APPLICATION NO.	FILING DATE	FIRST NAMED INVENTOR	ATTORNEY DOCKET NO.	CONFIRMATION NO.
10/614,557	07/07/2003	Frank Yang	PAT-1512	5796
7590 05/20/2005			EXAMINER	
Raymond Sun			SZUMNY, JONATHON A	
12420 Woodhall Way Tustin, CA 92782			ART UNIT	PAPER NUMBER
			3632	
			DATE MAILED: 05/20/2005

This is the fourth office action for application number 10614,557, Trash Can Assembly, filed on July 7, 2003.

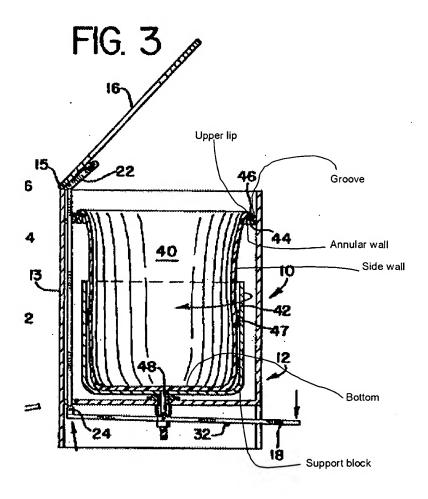
Claims 12, 13, 16 and 17 are rejected under 35 U.S.C. 102(b) as being anticipated by U.S. Patent number 5,125,526 to Sumanis.

Sumanis '526 discloses a trash can assembly (above), comprising: a shell (12) having a top end and a bottom end; a liner (40) defining a container body having a bottom (above) and an enclosing side wall (above), the liner fitted inside the shell; a lid (16) fitted over the top end of the shell; and a support block (above) provided adjacent the bottom end of the shell, wherein the liner inherently can be positioned in a first position with the support block located side-by-side with the side wall of the container body (as shown above), and in a second raised position with the support block located below the bottom of the container body (for instance, when the liner is raised and removed from the shell), wherein the enclosing side wall has an upper lip (above), and wherein the assembly further includes an annular wall (above) provided at the top

end of the shell, the annular wall having a groove (above) which exposes a portion of the upper lip, wherein the assembly further includes a foot pedal (18) positioned adjacent the bottom end of the shell, wherein the assembly further includes a link assembly (20,22) coupling the foot pedal and the lid.

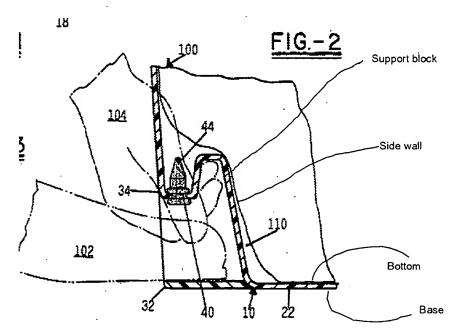
Claims 12 and 14 are rejected under 35 U.S.C. 103(a) as being unpatentable over U.S. Patent number 5,390,818 to LaBuda in view of U.S. Patent number 6,808,081 to Citro.

LaBuda '818 discloses a trash can assembly, comprising: a shell (12) having a top end and a bottom end; a liner (100) defining a container body having a bottom (above) and an enclosing side wall (above), the liner fitted inside the shell; and a support block (above) provided adjacent the bottom end of the shell, wherein the liner can be positioned in a first position with the support block located side-by-side with the side wall of the container body (as above), and in a

second raised position with the support block located below the bottom of the container body (when, for instance, the liner is raised and removed from the shell), wherein the assembly further includes a base (above) provided at the bottom end of the shell, with the support block positioned on the base, and with the bottom of the container body seated on the base when in the first position (as above). However, LaBuda '818 fails to specifically teach a lid to be fitted over the top end of the shell. Nevertheless, Citro '081 teaches the well known practice of fitting a lid (20) over a top end of a shell (12) of a trash can assembly. It would have been obvious to one of ordinary skill in the art at the time the invention was made to have fitted a lid over the top end of the shell of LaBuda '818 so as to assist in thwarting unwarranted access to the inside of the shell.
